**Blackmoorfoot Road, Huddersfield
Proposed Access Arrangements
Stage 1 Road Safety Audit**

May 2025 (Rev 1)

Miller Homes & Vistry Homes Limited

Table 2.6 Problem 6

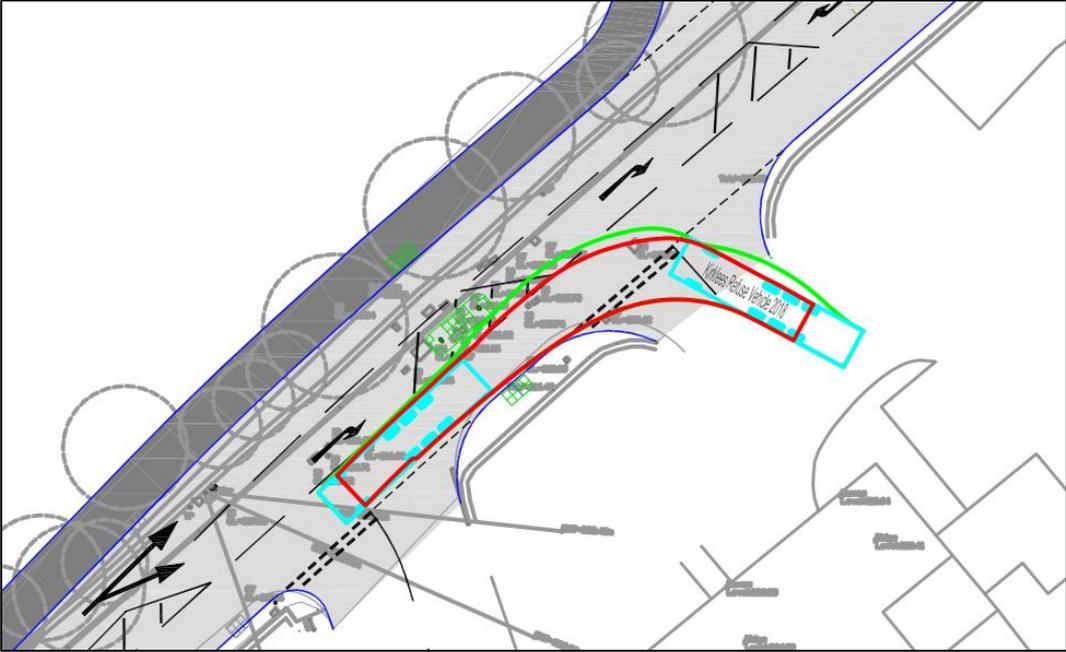
PROBLEM	
Location	Blackmoorfoot Road – Public House access.
Summary	Potential for refuse/delivery vehicles overrunning the pedestrian refuge island.
<p>A swept path analysis is provided of a Kirklees refuse vehicle turning left out of The Sands House public house onto Blackmoorfoot Road.</p> <p>The analysis indicates that the manoeuvre is extremely tight, with minimal margin for error, due to the proximity of the proposed pedestrian refuge island located between the public house access and Sands House Lane. Based on the analysis presented, there appears to be a risk that larger vehicles could overrun or collide with the refuge island.</p> <p>Furthermore, the assumed starting position and orientation of the vehicle may not be practically achievable when considering the internal layout of the public house and the location of the bin store. In reality, larger vehicles may adopt an alternative exit path, which may increase the likelihood of a vehicle overrunning or striking the refuge island, resulting in a potential vehicle/pedestrian collision or damage to the street furniture.</p> <p>It is worth noting that the analysis adopts an inconsistent approach, with the right turn entry movement showing the vehicle travelling to the western frontage of the site, whereas the exit assumes an origin from the rear of the public house.</p>

Recommendation	
<p>It is recommended that the swept path analysis is revisited to ensure the exiting vehicle is realistically positioned and oriented. Following the revised analysis, should the swept path impact on the proposed refuge island, it is further recommended that the island be repositioned or redesigned to ensure all vehicle movements can be comfortably accommodated.</p>

Table 2.7 Problem 7

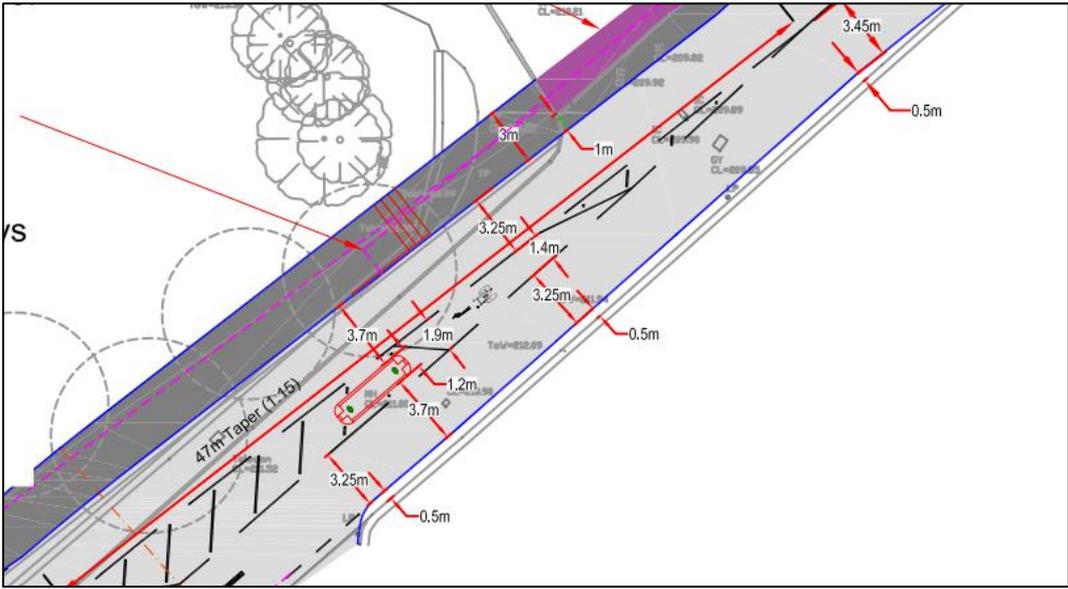
PROBLEM	
Location	Blackmoorfoot Road access.
Summary	The splitter island may result in vehicle/cyclist collisions.
<p>The proposed design includes a 1.2m wide splitter island intended to protect cyclists turning right from Blackmoorfoot Road into the development. Through lanes of 3.7m are provided adjacent to the splitter island.</p> <p>Guidance contained within LTN 1/20 and Chapter 6 of the Traffic Signs Manual 'Traffic Control' state that lane widths between 3.2m and 3.9m should be avoided as it can encourage drivers to attempt unsafe overtaking of cyclists, when there is insufficient space to do so.</p> <p>Whilst the Road Safety Audit Team agrees that the splitter island is an important feature of the scheme, as a consequence, westbound and eastbound cycle traffic could be 'squeezed' by drivers misjudging the passing clearance, resulting in a potential vehicle/cyclist collisions.</p>

Recommendation	
<p>The Road Safety Audit Team's preferred option would be to provide lane widths of 4.0m past the splitter island, consistent with the pedestrian refuge island opposite the public house. However, the Overseeing Organisation has confirmed that this is not feasible, due to the resultant impacts on either the taper length or the right turn lane length.</p> <p>As such, it is recommended that either the right turn cycle facility and island are removed or additional measures are provided to discourage overtaking such as widening the island, providing red thermoplastic surfacing within the central hatching on both the approach to and around the island (to visually reinforce the through lane width), provide road markings (cycle symbol for example) past the island to indicate a cyclists expected road positioning or whether warning signage could be provided.</p>

Table 2.8 Problem 8

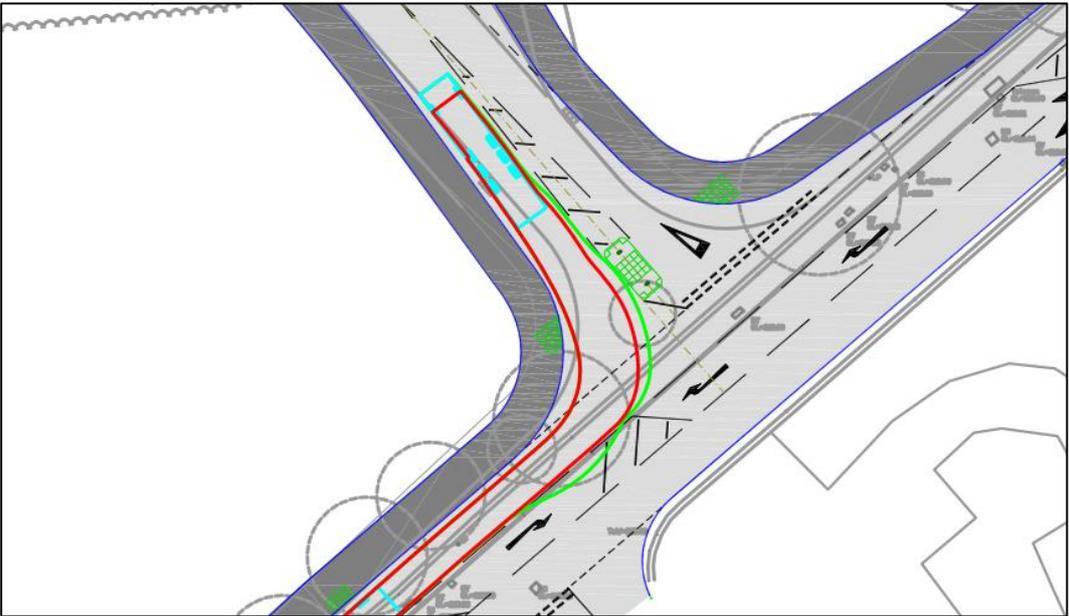
PROBLEM	
Location	Blackmoorfoot Road access.
Summary	The width of the pedestrian refuge island may result in vehicle/cyclist collisions.
<p>The side arm of the junction includes a 2.0m wide pedestrian refuge island, connecting to a 3.0m wide shared footway/cycleway along Blackmoorfoot Road. The Road Safety Audit Brief states that the reduced width of the island has been provided in order to minimise tree loss.</p> <p>The swept path analysis confirms that both buses and refuse vehicles entering the development require the full width of the lane, with minimal margin for error, passing in very close proximity to the island.</p> <p>Although the Road Safety Audit Team acknowledges that use of the island by larger bicycles may be limited, there is concern that the narrower island width could lead to vehicles encroaching on cyclists using the island, if a cyclist (particularly a less experienced rider) does not position themselves entirely within the island, increasing the risk of a vehicle/cyclist collision.</p>

Recommendation	
It is recommended that the island is increased to 3.0m in accordance with LTN 1/20 guidance.

Table 2.9 Problem 9

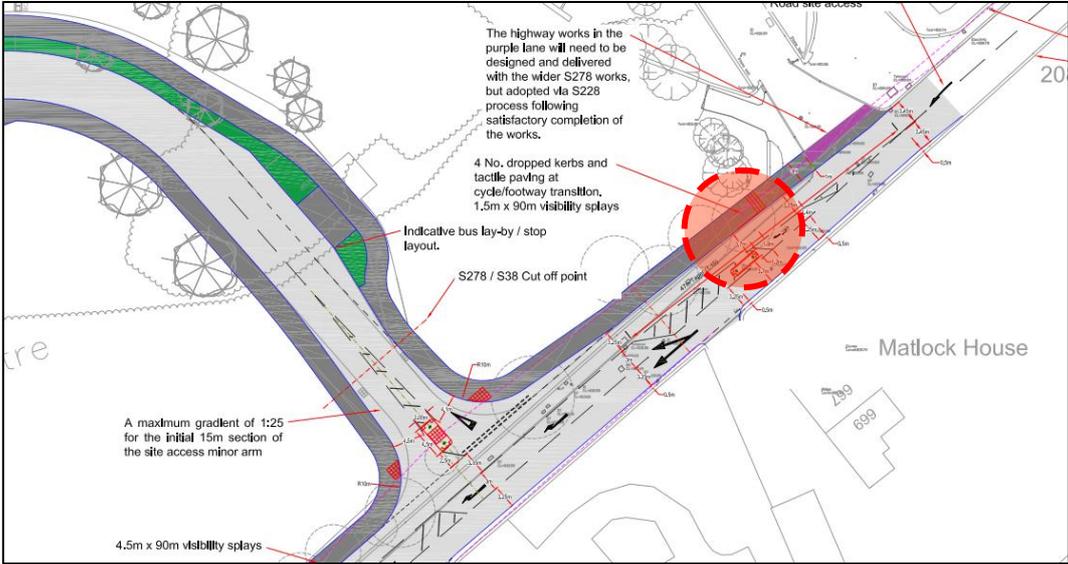
PROBLEM	
Location	Blackmoorfoot Road access.
Summary	Lack of advisory cycle lane road markings
<p>A dropped kerb, tactile paving and advisory cycle lane road markings are provided to the west of the junction to denote the start of the shared footway/cycle provision. At the end of the shared footway/cycle, dropped kerbs and tactile paving are provided, however the advisory cycle lane markings have not been provided (consistent with the Felks Stile Road junction).</p> <p>The provision of a short length of advisory cycle lane, raises awareness of the likelihood of a cyclist entering the carriageway, therefore the absence of the road markings could increase the potential for a cyclist being struck by an oncoming vehicle, discharging into the carriageway.</p> <p>Although it is acknowledged that this is a preliminary design, the use of tactile paving at the start and end of the shared facility, rather than corduroy, may cause confusion for visually impaired users by failing to distinguish between pedestrian and cycle routes.</p>

Recommendation	
It is recommended that a short length of advisory cycle lane road markings are provided at the end of the shared footway/cycleway and that the tactile paving is stipulated corduroy paving at the detailed design stage.
